ENGINEERING CHANGE NOTICE

1. ECN 100220

3. Originator's Name, Organization, MSIN, and Telephone No. J.D. Axford, KEH, E6-31, 6-6071			4. Date 10/16/92	
5. Project Title/No./Work Order No. Grout Processing Support Facility Drain Field Expansion/ER3077		6. Bldg./Sys./Fac. No. MO-392		7. Impact Level 4 / SC-3

12. Description of Change
Documents affected: ER2567-C1, Rev 0, H-2-140591, sheets 1 & 2, Rev 0

DETAIL 5
SCALE: NONE

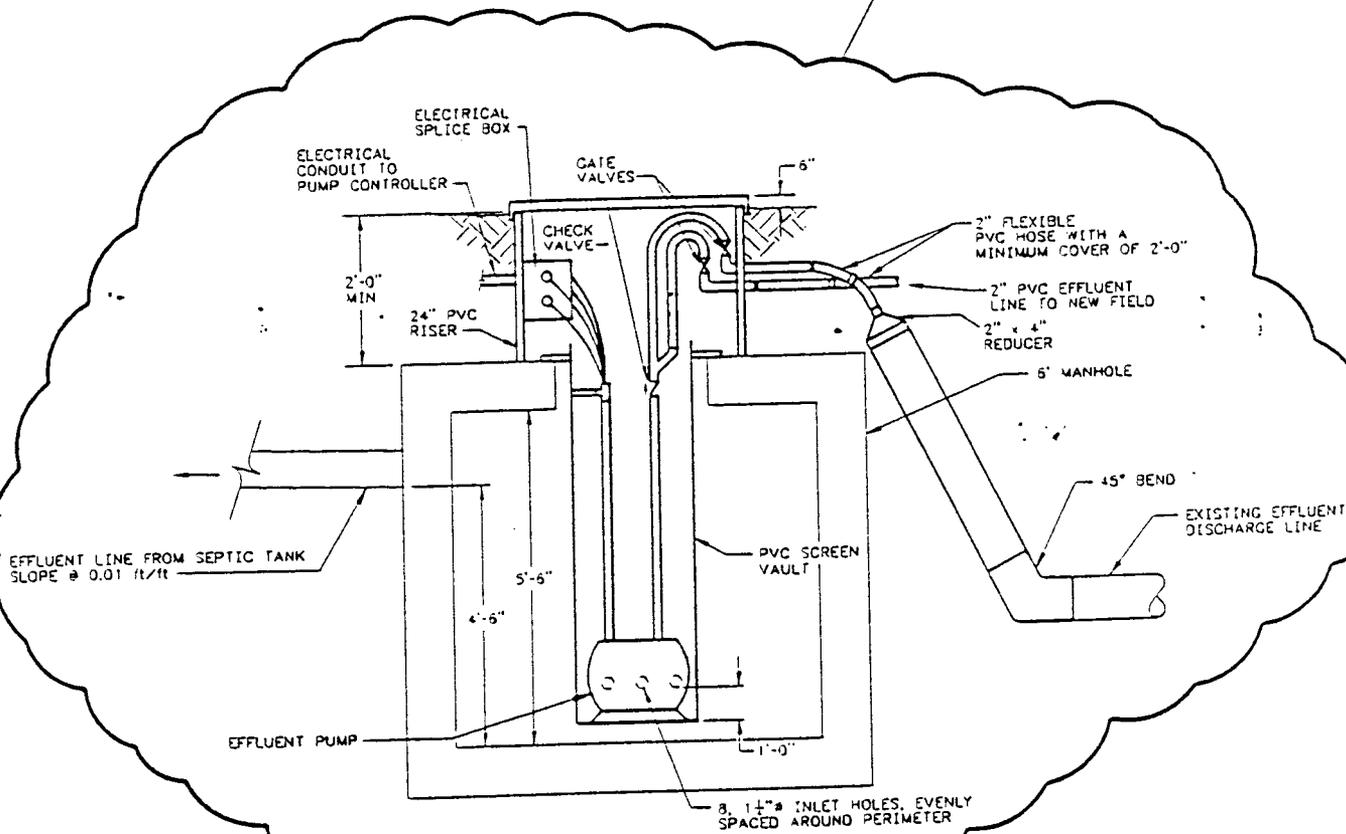
Ref. Dwg. H-2-140591	Sh. 1	Rev. 0	Prepared By BA LORENZO	Checked By <i>E. S. [Signature]</i>	ECN No. ER2567-1	Page 4/7
-------------------------	----------	-----------	---------------------------	--	---------------------	-------------

ZONE A-CS.6

REVISE

Ref. Dwg.
H-2-140591

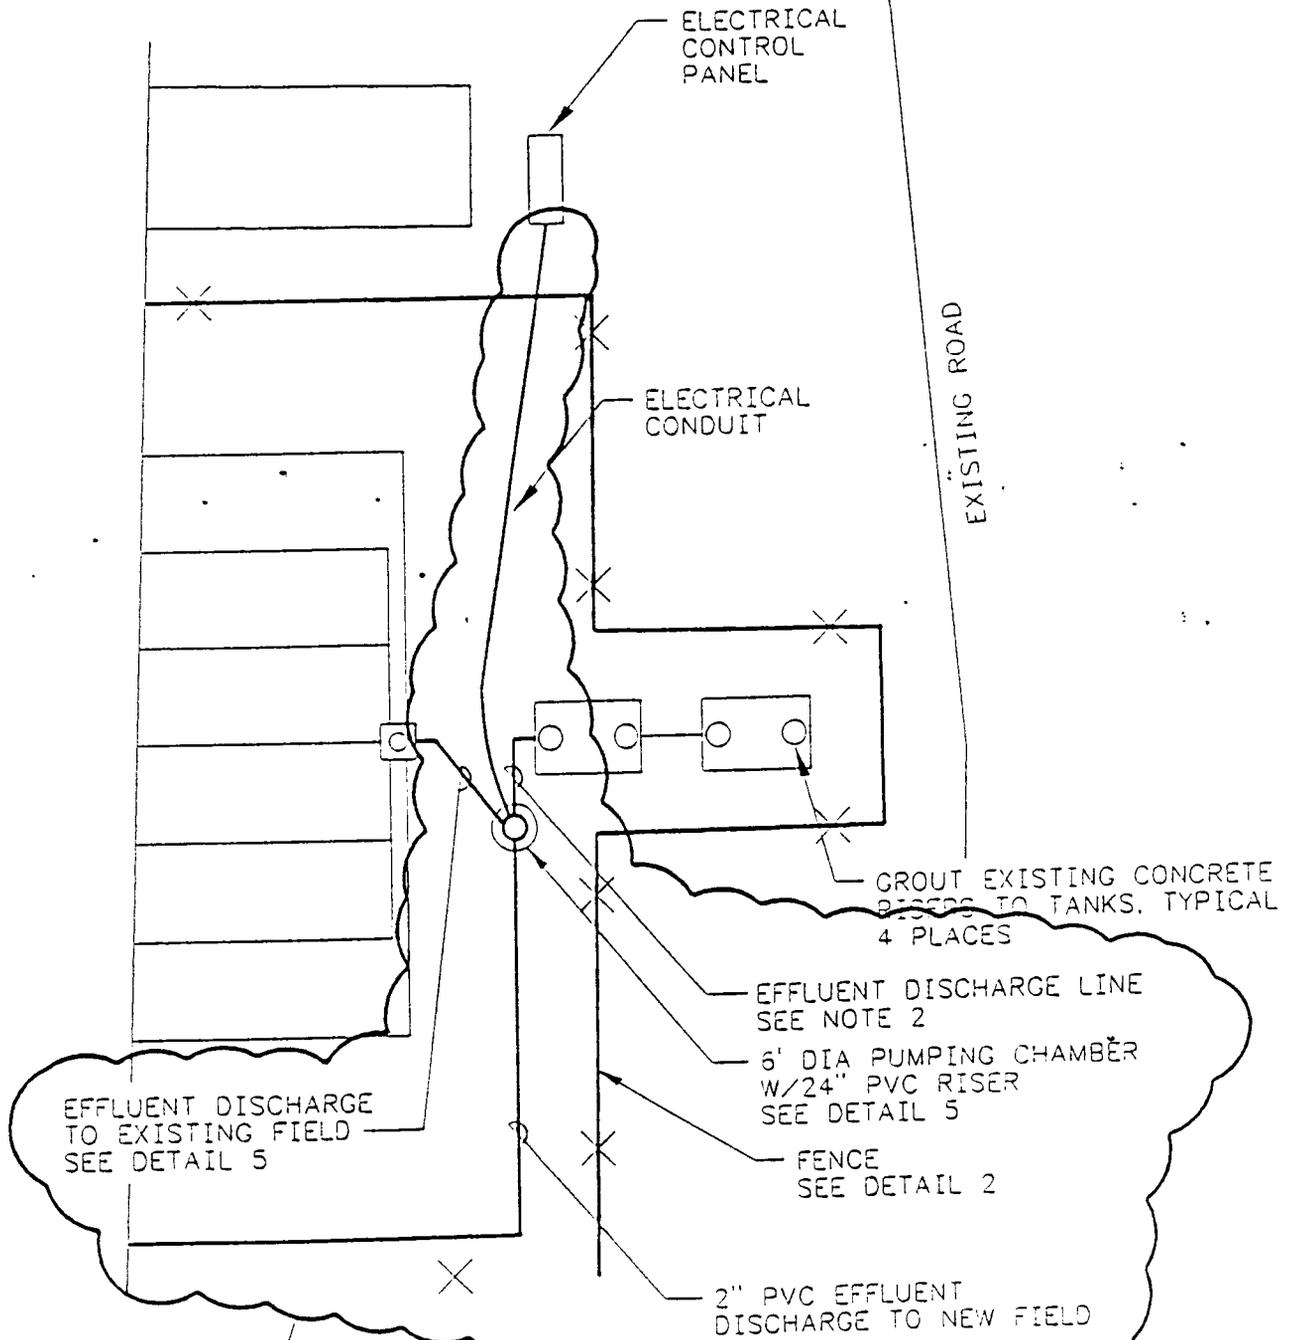
ZONE B1.2

REVISE

1. EXISTING EFFLUENT DISCHARGE LINE TO BE CUT AND REDIRECTED TO PUMPING CHAMBER. CUT AT DISTANCE FROM TANK SUFFICIENT TO INCORPORATE A 90° BEND.
2. FIELD LOCATE COMPONENTS WITHIN PVC RISER, SUBJECT TO APPROVAL OF KEH CONSTRUCTION MANAGEMENT.

ADD
